## Product Bulletin

### Introduction of improved plug connector in 117- CSR electrical equipments

Fig.1 New connector for 117 CSR electrical equipment

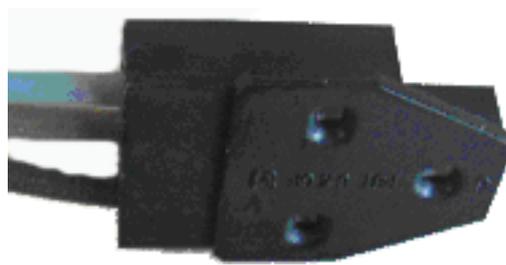
The general size of the new plug is similar to the previous one. From figure 1 you can see the new terminal plastic box with a different hole shape and smaller size for the FUSITE<sup>®</sup> pin holes.

The cluster contacts, presently also used for inside our motor connection to the FUSITE<sup>®</sup>, is now used with the new terminal box.

Reason for the smaller holes in the plastic box is to obtain a tighter push fit. Push-on force is thus slightly increased compared to the old type.
